Access Compliance Report Public Rights-of-Way (Curb Ramps)

Intersection ID: 12257 Main Street: W 3RD ST Cross Street: S_POPLAR_ST Location: **Overall Compliance: No ADA ID: 8DB53AC4E877** Ramp Type: Perpendicular Diagonal Initial Pass/Fail: Fail Severity Score: 21.25

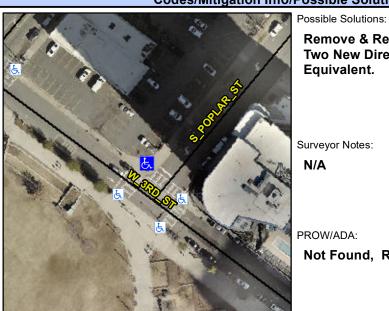
Surveyor Notes:			N/A
N/A			N/A
			N/A
			N/A
			N/A
PROW/ADA:			N/A
Not Found, R304.5.1, R304.	5.3		N/A
			N/A
Total Cost:	5	3200.00

Field Measurements/Component Compliance							
Compli	ance Description	Data	Compl	liance	Description	Data	
N/A	Ramp Length (in)	120.0	Yes	Ramp	Slope (%)	5.9	
No	Ramp Width (in)	46.5	No	Ramp	XSlope (%)	5.8	
N/A	Flare Type LT	N/A	N/A	Flare	Type RT	N/A	
N/A	Flare Slope LT (%)	N/A	N/A	Flare	Slope RT (%)	N/A	
N/A	Flare Traversable LT?	N/A	N/A	Flare	Traversable RT?	N/A	
N/A	Landing Length (in)	N/A	N/A	DWS	Provided?	N/A	
N/A	Landing Width (in)	N/A	N/A	DWS	Contrast?	N/A	
N/A	Landing Slope (%)	N/A	N/A	DWS	Length (in)	N/A	
N/A	Landing X Slope (%)	N/A	N/A	DWS	Full Width?	N/A	
N/A	Landing Curb? (Y/N)	N/A	N/A	DWS	Offset (in)	N/A	
N/A	Shared Landing?	N/A					
N/A	Gutter Ponding?	N/A	N/A	Gutte	r Slope (%)	N/A	
N/A	Gutter Lip Ht (in)	N/A	N/A	Gutte	r X Slope (%)	N/A	
N/A	Painted X Walk1?	Yes	N/A	Paint	ed X Walk2?	Yes	
	X Walk 1 Direction	To SW		X Wa	lk 2 Direction	To SE	
N/A	X Walk 1 Width (in)	161.0	N/A	X Wa	lk 2 Width (in)	113.0

X Walk 1 Slope (%)	3.8		X Wa	lk 2 Slope (%)	4.4	
	X Walk 1 X Slope (%)	4.0		X Wa	lk 2 X Slope (%)	4.1	
N/A	Ramp inside XWalk1?	Yes	N/A	Ramp	inside XWalk2?	Yes	
	Road Slope (%)	4.8	N/A	Clear	Space?	N/A	
	Road X Slope (%)	1.4	N/A	Clear	Space to XWalk (in)	N/A	
N/A	Any Obstructions?	N/A	N/A	Storm	Grate/Utility Hazard?	N/A	
	Obstruction Type			Storm	n Grate/Utility Type		
		N/A				N/A	
			Yes	Surfa	ce Condition? (G/P)	Good

W 3RD ST Street 1 Name Stop Condition-Street 2 Signal **S POPLAR ST** Street 2 Name Stop Condition-Street 1 Signal Remove & Replace Curb Ramp With Two New Directional Ramps or Equivalent.
